REED COLLEGE
REED RESEARCH REACTOR
LICENSE NO. R-112
DOCKET NO. 50-288

RESPONSES TO THE
REQUEST FOR ADDITIONAL INFORMATION
DATED MAY 20, 2011

Docket: 50-288
License No: R-112
Subject: RAI TAC NO. ME1583, dated March 8, 2010.

Figure 1 Core k-effective vs. % moderator void

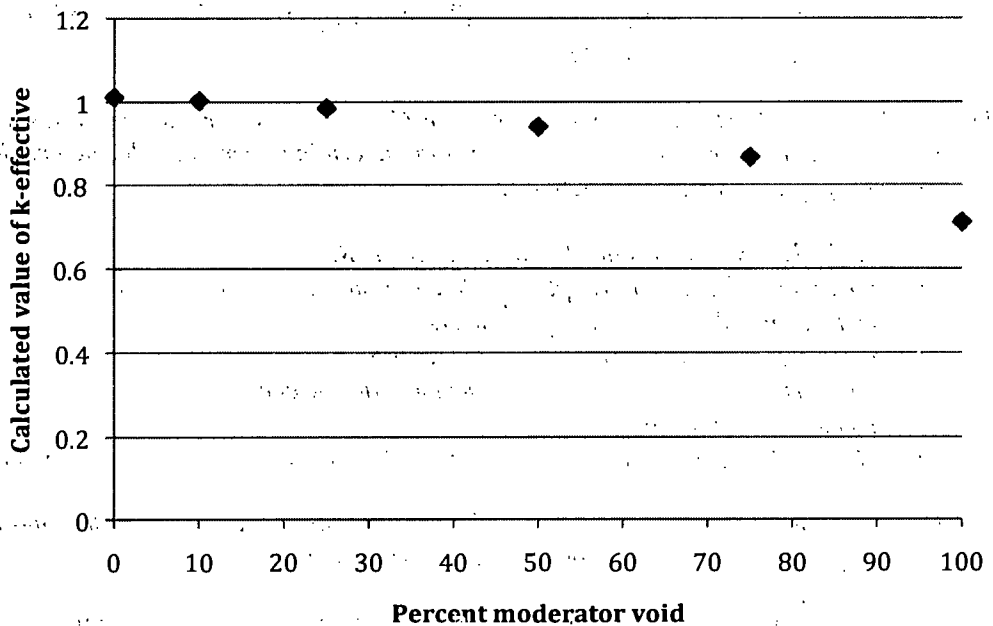
A question arose whether the calculated value for the void coefficient of reactivity is too large, especially when compared with calculated values from other similar facilities. Section 8 of Attachment A states that the average void coefficient over the range from 0% void to 100% void is $-\$0.83$ per percent void. This is very similar to the $-\$0.86$ value calculated for the OSTR and compares reasonably well with the measured OSTR value of $-\$0.51$ per percent void. As discussed below, it is highly improbable that the RRR could be operated with more than a few percent moderator void present in the core. The reactivity coefficient for the RRR within such an operating envelope is on the order of $-\$0.12$ per percent void.

Figure 1 shows k_{eff} vs. percent of moderator void. Removal of 100% of water from the core results in the introduction of \$54 negative reactivity. The graph indicates that removing any amount of water from the core will always result in the introduction of negative reactivity. The slope of the curve in terms of Δk per percent or \$ per percent increases with increasing percent void.

It is understood that in order to calculate a void coefficient one varies density while holding temperature constant. To calculate the void coefficient, we first calculated k_{eff} of the reactor with the in-core water moderator at nominal temperature and normal corresponding density. We then reduced in-core water density to 90% of the original value and re-calculated k_{eff} at the same temperature. This process was repeated with in-core water densities of 75%, 50%, 25% and 0% of the original densities. The resulting eigenvalues for each core state are tabulated below and plotted in Figure 1.

Figure 5 Reg Rod Worth for RRR Core

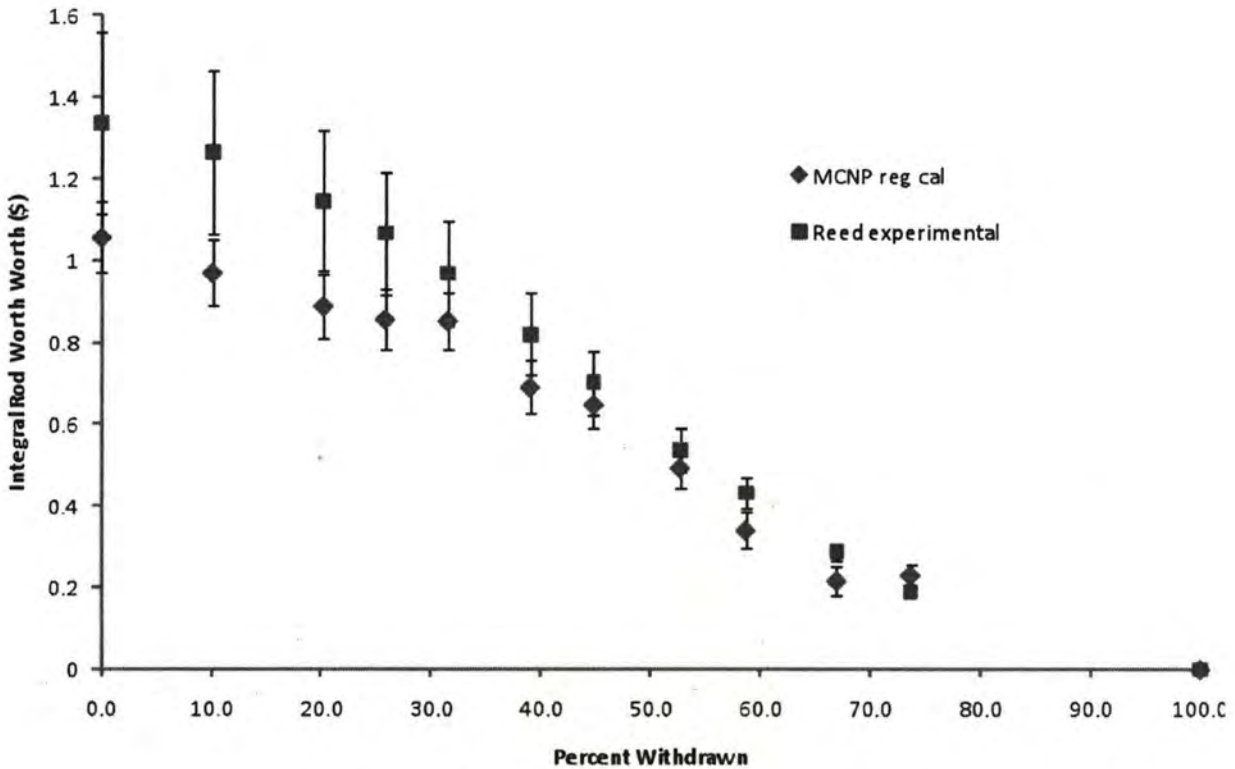
It has been noted that Figure 5 of Attachment A indicates that the calculated IRW value of the reg rod is \$1.06 and the measured value is \$1.34. Furthermore, some of the calculated reactivity values are non-physical, that is *withdrawing* the rod seems to introduce *negative* reactivity over certain increments. In response, during initial modeling attempts, it was found that the control rods in the MCNP model had a calculated worth that was significantly higher than the recent measured values. It was reasoned that not only had the fuel experienced some depletion, but the control rods had as well. In order to account for this, control rod boron content of the MCNP model was reduced as discussed in section 4 of Attachment A. All three control rods were depleted in exactly the same manner such that the calculated value of total rod worth was reduced to essentially the same value as measured total rod worth. Note, however, that the Reg rod is located in the E-ring while the other two rods are located in the C-ring. The reg rod is thus depleted significantly less than the other two rods. By depleting all three control rods in an identical manner, the end result was that the reg rod was significantly over-depleted and the shim and safe rods were slightly under-depleted. The goal of the depletion simulation was to achieve good agreement between measured and calculated total rod worth. A more accurate approach would have been to deplete each control rod in such a manner that the calculated and measured worth of each rod would be equal. Although this is a flaw in the model, safety calculations that involve control rod accidents are based on the *most* reactive rod sticking or ejecting. Values used in these safety calculations were based on measured rod worth, not calculated rod worth.

In accordance with Reed College operating procedures, the Reg rod is calibrated first, and is withdrawn sequentially from full insertion (0% withdrawn) to full withdrawal (100% withdrawn). After the reg rod is calibrated, the reactor is configured with the reg rod and shim rod fully withdrawn and the safe rod inserted to maintain criticality. This results in two control rods fully withdrawn and the third near mid height. The safe and shim rods are then calibrated by pulling the safe rod, measuring the period and then inserting the shim rod to re-establish criticality at the initial starting power. The result of this method is that the shim and safe rods curves are based on measurements taken on only the upper portions of the rods. The remainder of the rod worth curves is established by fitting a third order polynomial to the collected data. Results are also customarily plotted to show rod worth as \$0.00 when the rod is 100% withdrawn. The remainder of the rod worth curves indicates the amount of reactivity inserted by inserting a control rod to the indicated position.
